ADDENDUM NO. 1

DATE: **March 30, 2026**
OWNER: **Town of Tignall**
PROJECT: **Wastewater Treatment Plant Improvements**
C & S PROJECT NO.: **T7040.003**

**WWTP IMPROVEMENTS
FOR THE
TOWN OF TIGNALL
WILKES COUNTY, GEORGIA**

MODIFICATION TO EXISTING AERATION BASIN STRUCTURES

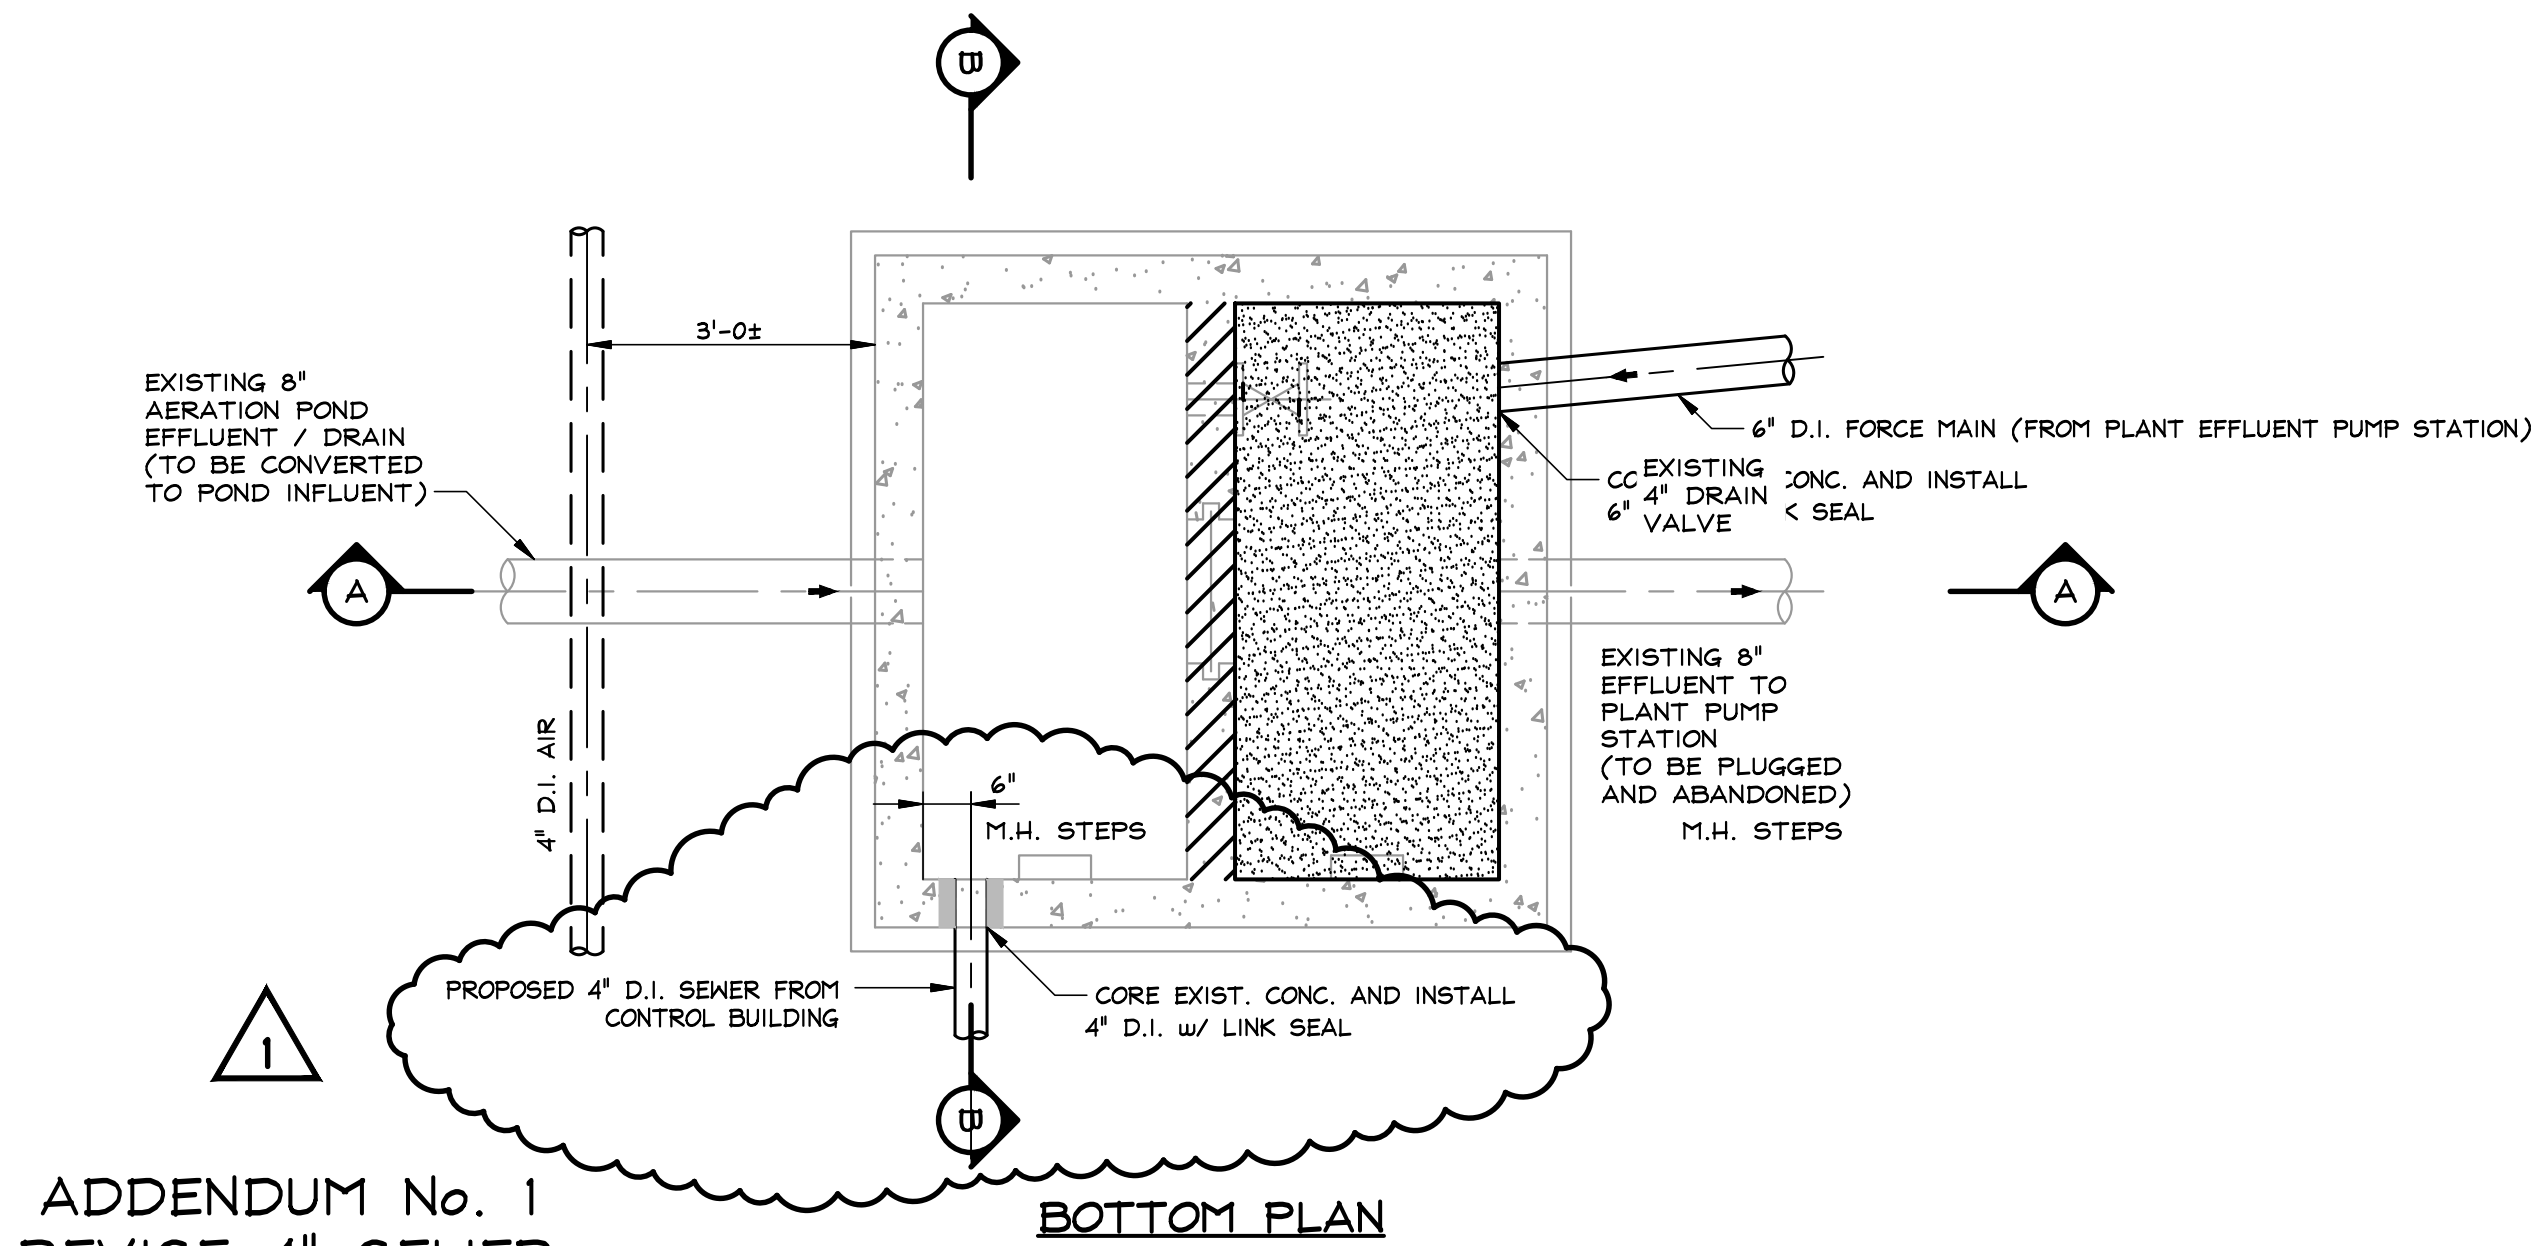
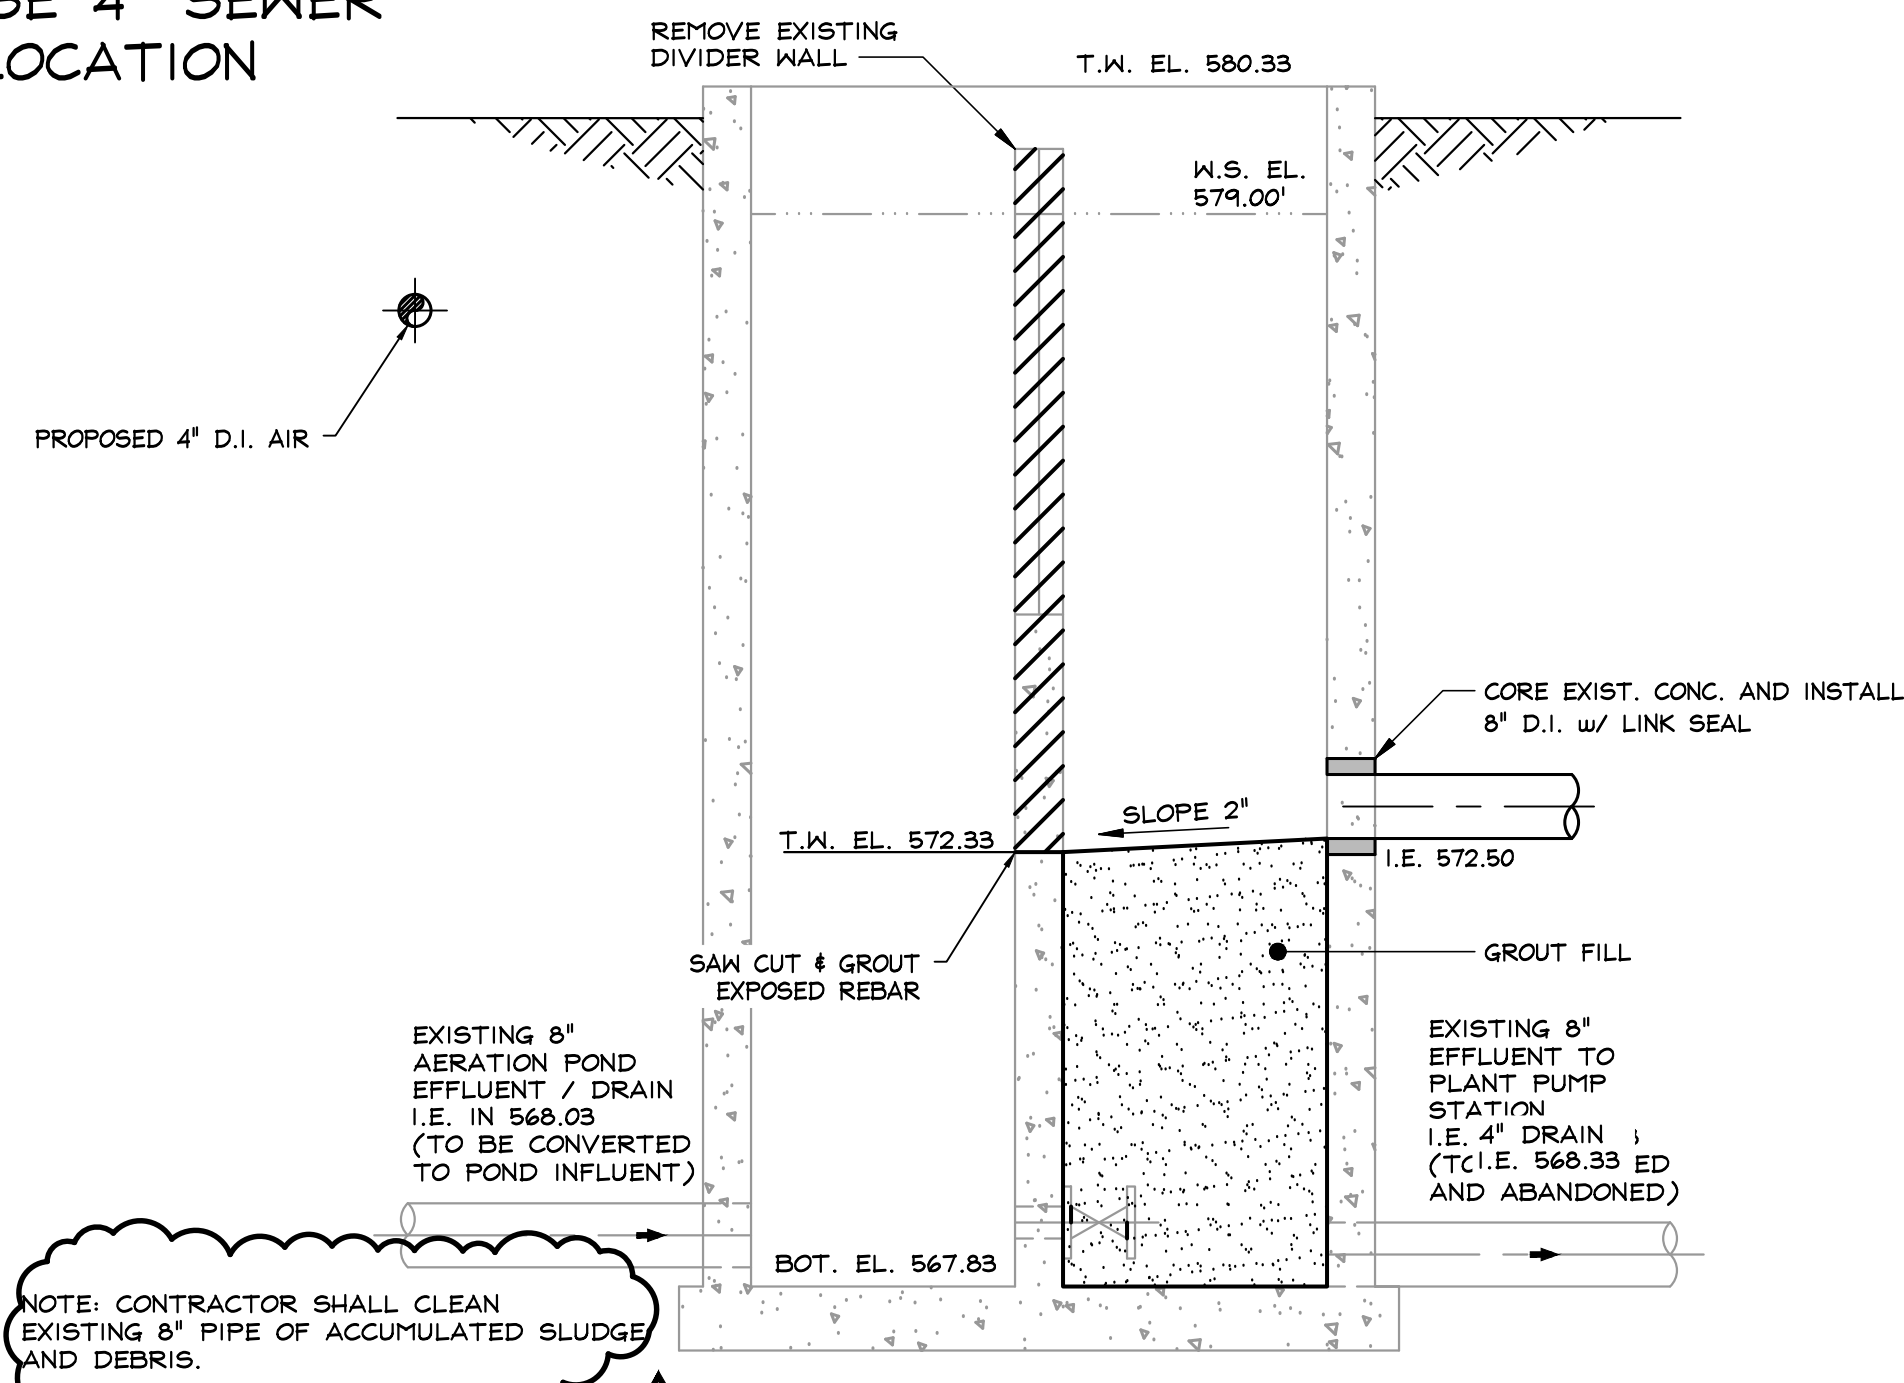
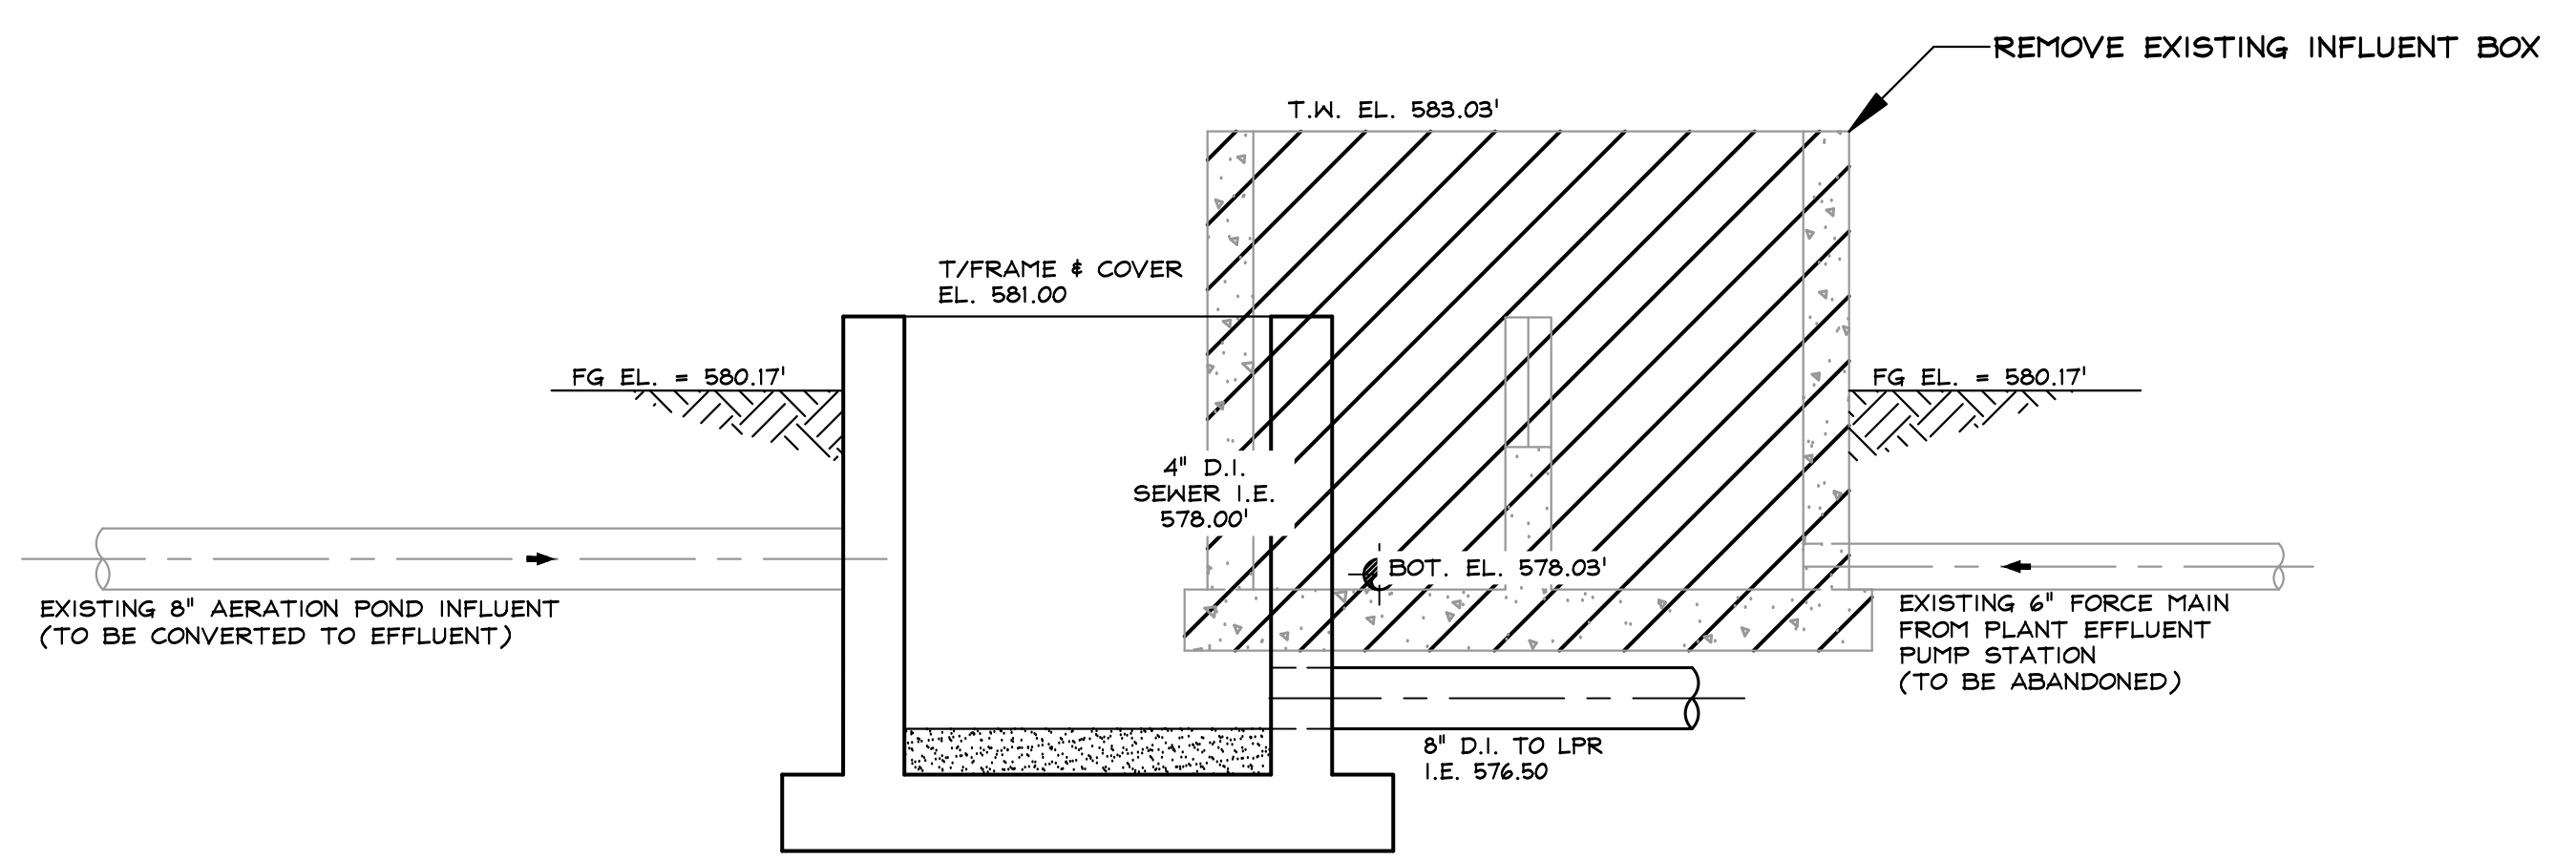
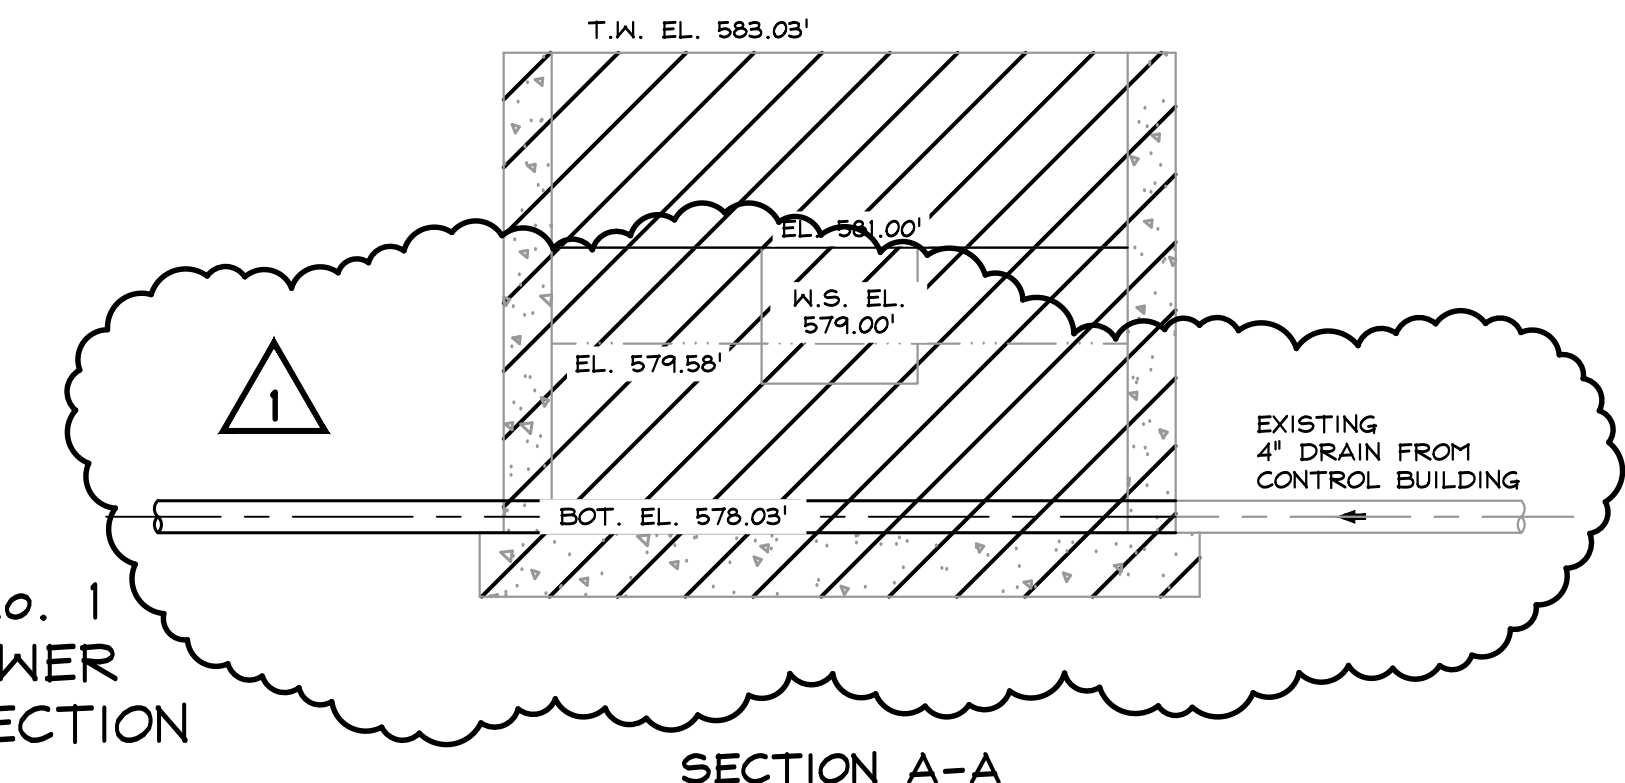
ADDENDUM No. 1
REVISE 4" SEWER
LOCATION

ADDENDUM No. 1
ADD NOTE

ADDENDUM No. 1
REVISE 4" SEWER
LOCATION/CONNECTION

ADDENDUM No. 1
REVISE 4" SEWER
LOCATION/CONNECTION
